service bulletin

M64-6
(Supersedes M50-7)

SUBJECT: Prevention of idling failures on four-cylinders engines.

ENGINES AFFECTED: All four-cylinder engines.

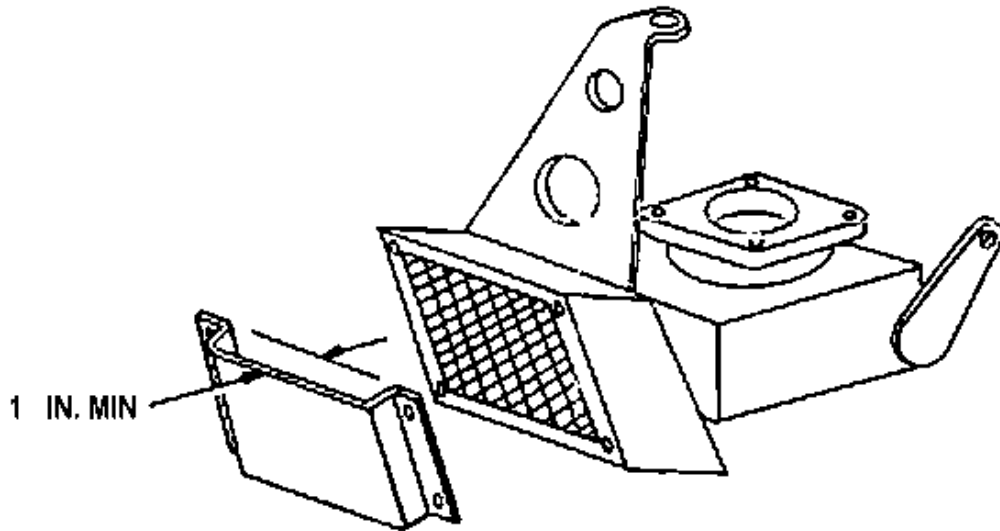
The foregoing is intended as helpful information to be remembered and applied whenever necessary. However, it is always a good safety measure to have a mechanical aid to help combat idling failures and we therefore refer you to the sketch illustrated below showing the suggested baffle arrangement which is very simple and can be very easily and economically made up and installed over the standard air filter. Our tests have indicated that this arrangement gives improved acceleration characteristics and minimizes the possibility of engine stoppage on sudden opening of the throttle.

1. Baffle metal must be stiff enough to prevent inward deflection toward the filter.
2. Note that a minimum distance of 1 inch must be maintained between baffle and filter as shown.
